GRAND HAVEN CHARTER TOWNSHIP

Community Development Memo

RE: Health Pointe PUD Amendment

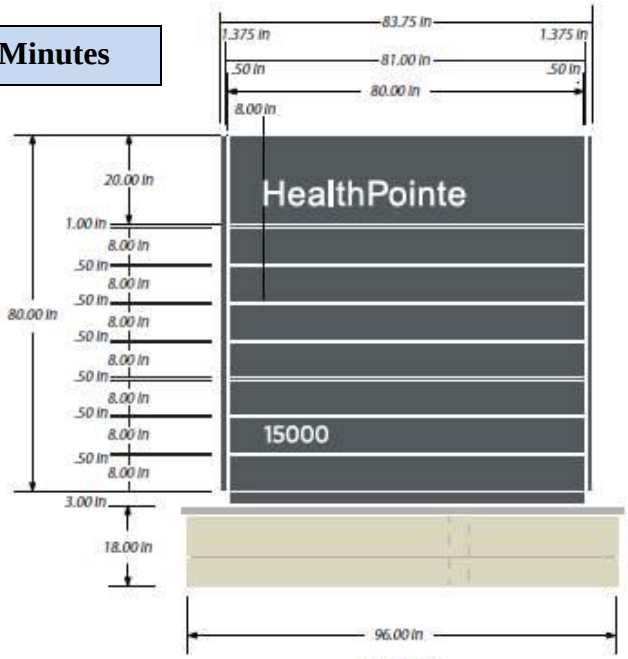
The 1998 Township Board Meeting Minutes, which list the conditions of approval for the original Meijer PUD also describe the permitted signage for the outlots. The condition states, approvals of monument (ground) signs for each outlot, not to exceed 52 square feet, and 5 feet high subject to review by the Planning Commission for location.

The Planning Commission recommends the Township Board approve this departure based on the following findings:

- Three ground signs, each 48 square feet in size and six feet in total height, are permitted because of the following findings.
  - ✓ The original Planned Unit Development approval memorialized in the March 9, 1998 Township Board meeting minutes permits one monument (ground) sign for each outlot, not to exceed 52 square feet and five feet in height, subject to review by the Planning Commission for location. This PUD Amendment comprises five of the six outlots.
  - ✓ The three permitted ground signs **reduce**↓ the amount of signage permitted under the 1998 PUD by 116 square feet.
  - ✓ A total height of six feet is permitted under Section 24.13 of the current Zoning Ordinance.

Curb and Gutter – 15A.10.7

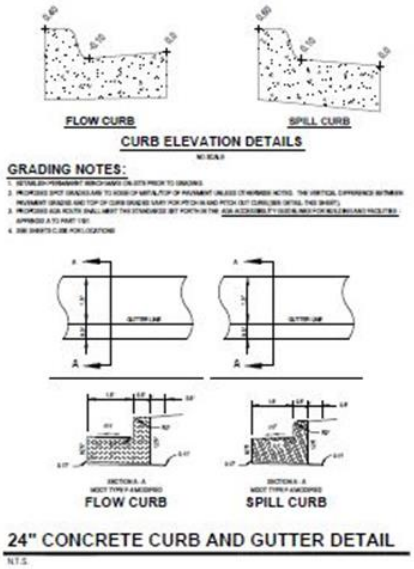
Applicant is requesting a departure from the Overlay Zone's curbing requirement, which states, generally, curbs must be used throughout the parking lot and paved areas. The Planning Commission may grant an exception upon a finding that overall stormwater disposition will be enhanced.

The Planning Commission recommends the Township Board **DENY** this departure based on the following findings:

- A departure from 15A.10.7 of the Zoning Ordinance, which requires concrete curb and gutter throughout the parking lot and paved areas, is denied.
  - ✓ The Planning Commission has consistently required curb and gutter throughout the parking lot and paved areas of developments in the Overlay Zone.
  - ✓ As required by Section 15A.10.7, the Developer did not provide compelling evidence to find that overall stormwater disposition will be enhanced if the curbing requirement is reduced.

Interior Landscape Island Dimensions – 15A.10.5

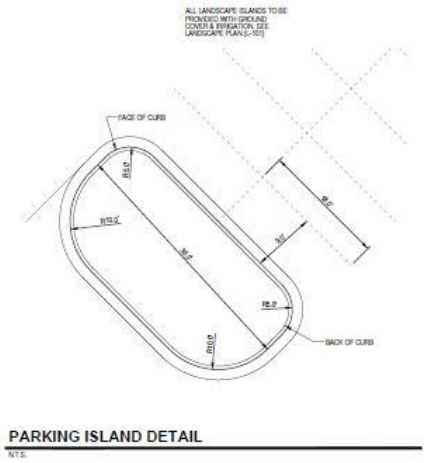
Applicant is requesting a departure from the Overlay Zone's interior landscape island requirements, which states, islands shall be located to improve traffic flow and views. Details on islands shall be provided including radii, length two feet

shorter than parking space depth, ground cover and any lighting or irrigation.

The Planning Commission recommends the Township Board deny this departure based on the following findings:

- Interior landscape islands shall be permitted to extend the length of the parking space, contrary to Section 15A.10.5 of the Zoning Ordinance, because of the following findings.
  - ✓ Aesthetics to the surrounding area will be **enhanced** because the interior landscape island will screen the entire length of the parking space.
  - ✓ The parking spaces surround sides of the building, and each abut a private road or access road. Due to the high visibility of this parking lot this departure is approved in order to provide additional screening from adjacent roadways.
  - ✓ This provision has not been uniformly enforced by the Township for other development projects in the Overlay Zone.
